Delegated officer report for planning application

Application no. CDN/26/0154

Proposal: Discharge of Conditions 3 (CMP), 7a (Ground conditions) and 12 (drainage) attached to Planning Permission referenced 144410/FO/2025.

Address: The Manchester College (Openshaw Campus), Ashton Old Road, Openshaw, Manchester, M11 2WH

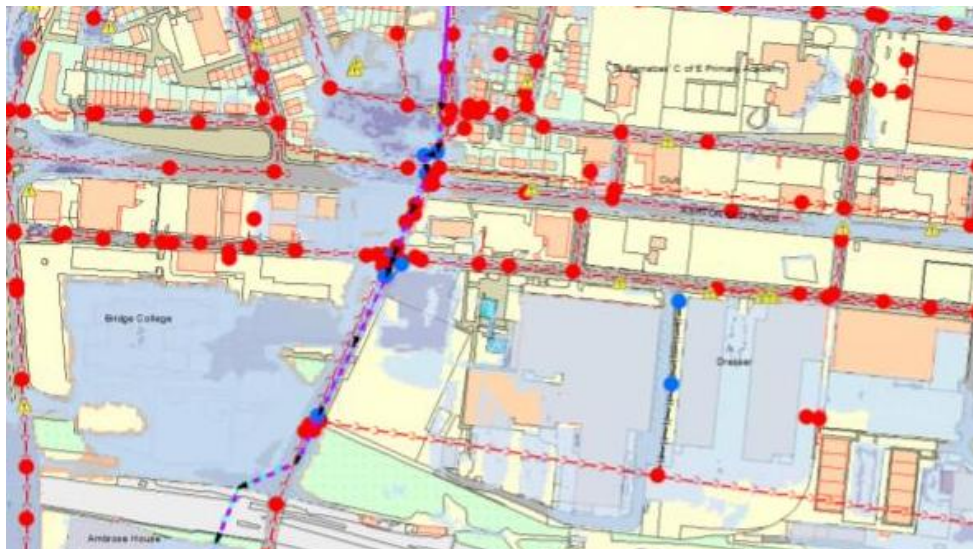
Given that the site lies within an area susceptible to surface water flooding, the drainage design must demonstrate how flows entering the site are managed and how the development will not exacerbate existing flooding mechanisms. This assessment is currently absent and must be addressed in a revised submission.
